## REFERRAL RESPONSE URBAN DESIGN

FILE NO: DA 598/2022

ADDRESS: 17 Dover Road ROSE BAY 2029

PROPOSAL: Demolition of existing at-grade car park, construction of new mixed-use development incorporating multi-storey car park, community centre, retail facilities and public domain upgrades.

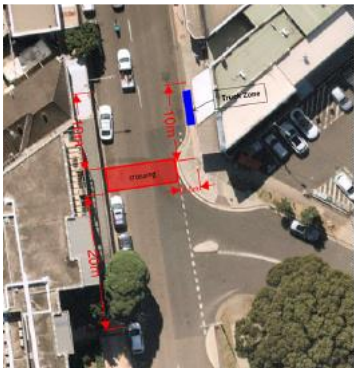
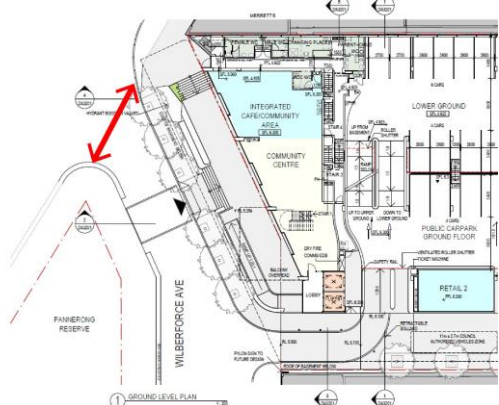
<p>The through-site link illustrated in the landscape and architectural drawings shows an indirect pathway for pedestrian movement that is dominated by two wide (two spaces wide each) and separate car park access locations and a centralised loading zone.</p>	<p><i>Paving is kerb free and the designed modified to ensure with a minimum 2.4m wide clear pedestrian zone width and direct sight lines.</i></p>	<p>While some improvements have been made since the pre DA, fundamentally pedestrians are still not being invited to move easily along lan Lane.</p> <p>The 'clear pedestrian zone' shown in the architect's response to urban design comments shows an indirect pathway which crosses both the car park entrance and exit and is impacted by retractable bollards (shown in the Landscaped plans).</p> <p>The Landscape Plans also imply pedestrians will use the narrow area allocated to a "pedestrian access path" (referred to under drawing L202), and not use the area allocated to 'carpark entry' or 'carpark exit'. The level change and proposed retaining wall at Dover Road also implies that pedestrians and vehicles are separated and do not share the same space. The location and operation of the loading zone blocks direct sight lines down the laneway and reduces pedestrian</p>

<p>access.</p> <p>A redesign of the laneway to be a shared zone that allow pedestrians, cyclists and vehicles to be limited to a 10km/hr speed and share the same space, similar to the approach taken at The Canopy at Lane Cove (see image below), is strongly recommended.</p>  <p>Figure 1 Google Street View of Birdwood Lane, Lane Cove</p>
Views along the link are obstructed by tall trees.	<p><i>As trees mature street views under the canopy will be provided. No design change proposed. Provision of an urban street canopy is considered desirable.</i></p>	<p>The location of proposed trees along lan Lane is not consistent between the photomontages shown in the design report and the landscape plans. For example, the image noted as 'View towards Dover Road through retail link' in the design report shows a tall tree centrally located in the space and surrounded by seating however the landscape plans show the trees close to the southern boundary with seating shown parallel to the side boundary.</p> <p>The rendered views in the landscape plans such as 'Laneway Looking East' appear to be slightly more accurate but they also appear to show that it would be possible to walk between the trees and the side boundary which is not consistent with the plans.</p> <p>The proposed trees within lan Lane have been identified as 'Livistona australis' on the landscape plans, however, these trees have not been identified within the Plant Schedule and no information has been provided with regards to its size and mature height. Further, the trees are located over the basement and are contained within 'square recessed tree grilles'. Additional information is required to ensure adequate soil depth has been achieved to sustain long term health.</p>

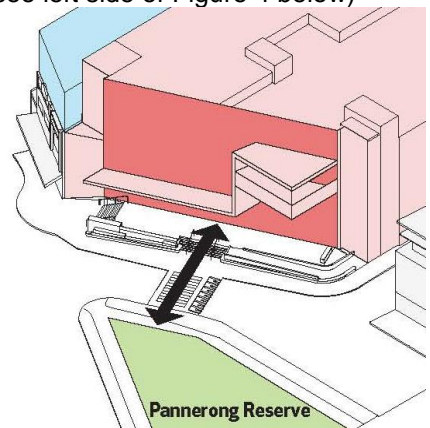
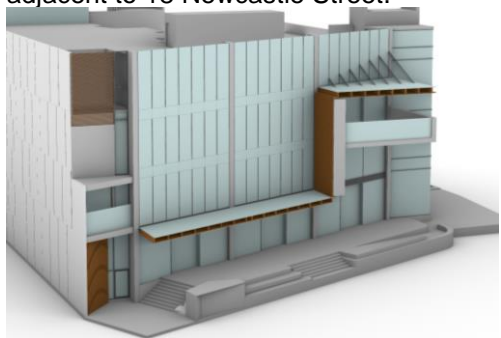
The proposed design not only obscures pedestrian sightlines between Dover Road and Wilberforce	<i>Refer changes made above.</i>	The risk of potential conflicts between pedestrians and vehicles remain as 'the clear pedestrian zone' indicated within the architect's response to urban design

<p>Avenue and limits pedestrian access it also creates potential conflicts between pedestrians and vehicles, resulting in an unsafe pedestrian environment.</p>		<p>comments, still requires pedestrians to cross the car park entrance and exit and travel through the loading zone.</p>
<p>There are several occasions when the unobstructed width of the pedestrian footpath is not a clear 2.5m width, as it incorporates large trees or accommodates access to the proposed raised terrace (see figure 2 and 3 below)</p>	<p><i>lan Lane: Tree pits and footpath configurations have been modified to deliver a minimum 2.5m clear pedestrian zone to tree trunks and 2.15m minimum paving width in lan Lane.</i></p>  <p><i>Wilberforce Avenue: Tree pits and footpath configurations have been modified to deliver a minimum 1.65m clear pedestrian zone at tree plantings and 1.35m minimum paving width. To achieve this the Wilberforce carriageway was reduced from 7.6m wide to 7.2m wide. To offset the narrow footpath width from 1.65m width a 600 mm street bench has been incorporated into the terrace design to provide above waist height clearance. Tree gratings are to be flush with paving.</i></p> <p><i>An option exists to replace the 1200mmx1200mm pits with 1200mm x 900mm to increase pavement widths to 1655mm. 1200mm wide pits will deliver the best tree growth conditions.</i></p>	<p>As mentioned above, the preferred width for clear path of travel for pedestrians is a minimum of 3.2m not 2.15m or 2.5m.</p> <p>Along lan Lane the proposed width of 2.15m and 2.5m is to the glass line and does not consider the elevated ground floor and proposed timber structure on the retail frontage. The actual clearance between the retail façade on the laneway and the tree pits is only 1.9m.</p> <p>The architect's response to the urban design comments also states that the retail façade is designed to be operable to increase 'permeability along the Laneway'. It is unclear how level access can be achieved through the operable facades given the difference between the proposed floor levels of the retail spaces and the shared laneway.</p> <p>Along Wilberforce Avenue the proposed 1.35m minimum paving width and 1.65m clear pedestrian zone is too narrow for comfortable pedestrian access in a busy centre. Movement along this street is further restricted by the proposed location of the Hydrant Booster Valves, the impact of which is clearly shown on the Northern Stair rendered view in the landscape architects plans.</p> <p>It is recommended that the raised foyer is setback further from Wilberforce Avenue to provide a minimum Continuous Accessible Path of Travel zone of 3.2m along the footpath.</p>

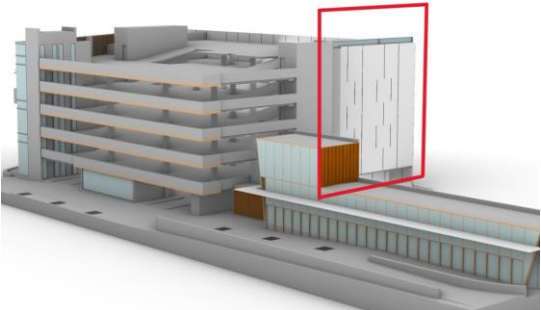
While the proposed location for the new pedestrian crossing would provide good access for people accessing the	<i>The option for an additional pedestrian crossing at Newcastle Street was investigated by the Landscape Architect and Traffic Engineer.</i>	The recommendations from the urban design comments to the pre-DA referred to pedestrians traveling <b>along</b> Newcastle Street and did not suggest an additional crossing <b>across</b> Newcastle Street. The comments

<p>retail/community facility, it creates an indirect path for those traveling along Newcastle Street and accessing the rest of the centre and this route would be narrow due to the terrace and proposed trees. To support activity in the centre it is strongly recommended a pedestrian crossing is located where it services the pedestrian desire line along Newcastle Street and that the primary stair to any elevated terrace also addresses Newcastle Street.</p>	<p>(shown below).</p>  <p><i>TTW advised “if the client would like to propose a crossing on Newcastle St (as shown below), there are a safety concern due to proximity of the proposed crossing and the truck zone as annotated. Markup below is my rough sketch to show the possible changes and constraints. The truck zone would need to be shifted to north since we need 10m distance from the crossing and the truck zone (trucks are a major obstruction for pedestrians’ visibility). On the other hand, 30m of on-street parking should also be removed on the western side of Newcastle St due to the location of crossing” Consequently the provision of a crossing is not included in this DA.</i></p> 	<p>related to relocating the proposed pedestrian crossing to provide a more direct connection between the northern corner of Pannerong Reserve and corner between Newcastle Street and Wilberforce Avenue, parallel to Newcastle Street (See figure below).</p> <p>This connection would have minimal impact on the current location of the truck zone. But if the truck zone is a problem, it could be relocated to be further away from the corner.</p>  <p><i>Figure 3 Ground Floor Plan annotated showing the recommended location of pedestrian crossing</i></p> <p>The realignment of the northern kerb on Wilberforce Avenue to widen the public domain is welcomed however the proposed elevated terrace located over the basement parking ramp has ‘filled’ this space and reduced the area available for pedestrian access along Wilberforce Avenue. The existing footpath width is 3.6m and the proposed design reduces it to approximately 2.25m. The proposed clear path of access for pedestrians between the proposed trees and the elevated entry terrace is only 1.65m.</p>
